DELEGATED APPLICATION REPORT

App Ref: PL/26/0804 Householder planning permission

Address: 2 LANCASTER CLOSE, READING, RG1 5HB

Proposal: Proposed single-storey rear / 2 Storey side & a garage conversion.

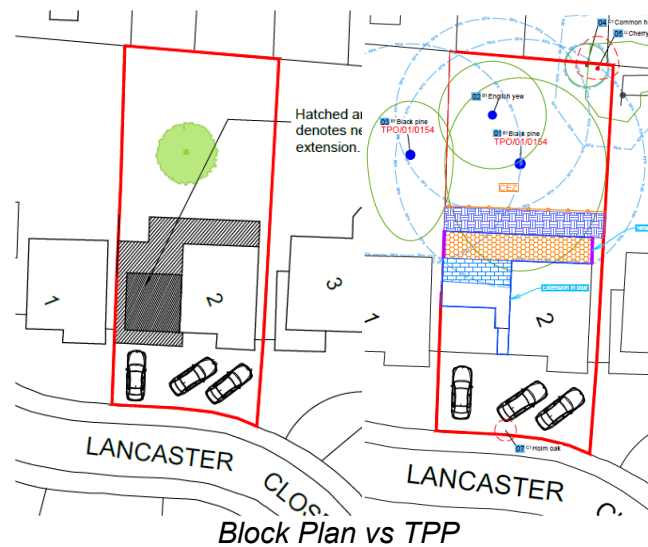
Currently, the submitted Arboricultural Impact Assessment (AIA) (see extract of the TPP below) does not relate to the current proposal (see extract of the block plan below) and instead appears to be the report previously submitted under application ref. PL/25/0233. An updated AIA and Arboricultural Method Statement (AMS) are required, and it was identified within the pre-application advice (ref: PL/25/0938), but it was not submitted under this application

With regard to this proposal, the proposed single-storey rear extension would be located within the root protection area (RPA) of the protected T5 Pine, as well as the protected T3 Pine situated on the neighbouring property. In addition, the proposed garage conversion/side extension would also fall within the RPA of the protected T5 Pine.

Drafting by the case officer for reference

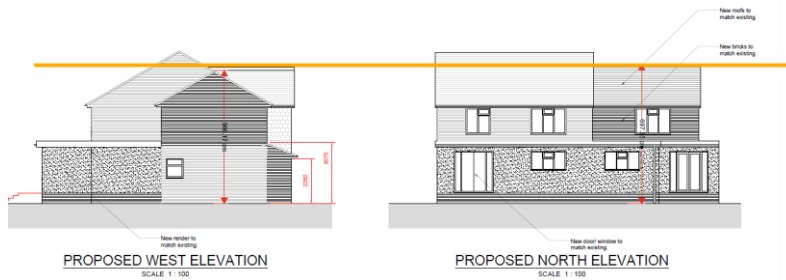
The proposed elevations indicate the provision of a raised patio with a height of approximately 0.5m. It is not shown on the proposed floor plans or block plan. Consequently, this assessment is based solely on the information presented within the submitted elevations, assuming that the patio would extend across the full width of the proposed rear extension, projecting approximately 1.2m from the wider section and approximately 3.7m from the narrower section, resulting in a straight rear edge. A drafting image, indicating the projection from the proposed rear extension, has been provided below to illustrate the approximate depth of the proposed patio and its relationship to both neighbouring properties.

However, the introduction of the raised patio would provide direct views towards the habitable room windows serving No. 3 Lancaster Close. Given that the boundary treatment is approximately 1.8m in height, the effective screening height would be reduced to approximately 1.3m when viewed from the patio level. Consequently, the proposal would increase opportunities for overlooking and result in an unacceptable loss of privacy to the occupants of No. 3 Lancaster Close.

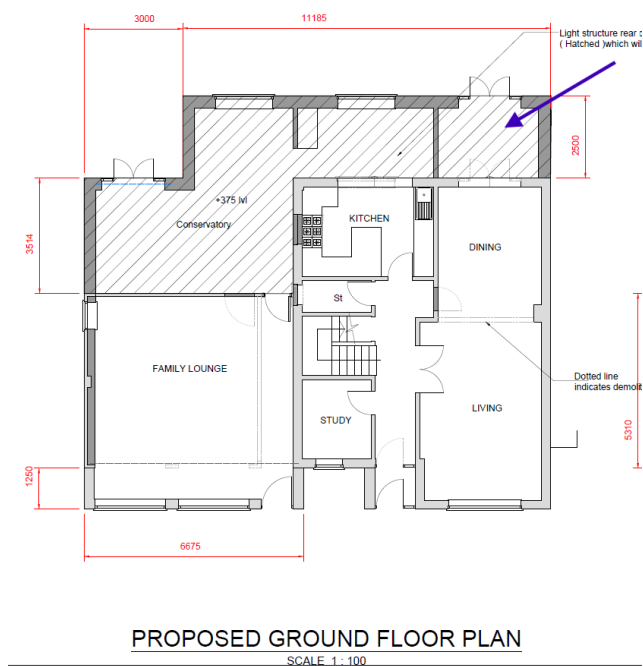
1. The overall height of the proposed first-floor side extension is not consistent between the proposed west and north elevations.

2. Part of the function of the proposed space is not labelled.

3. Proposed patio information is not provided on the proposed floor plan and block plan.
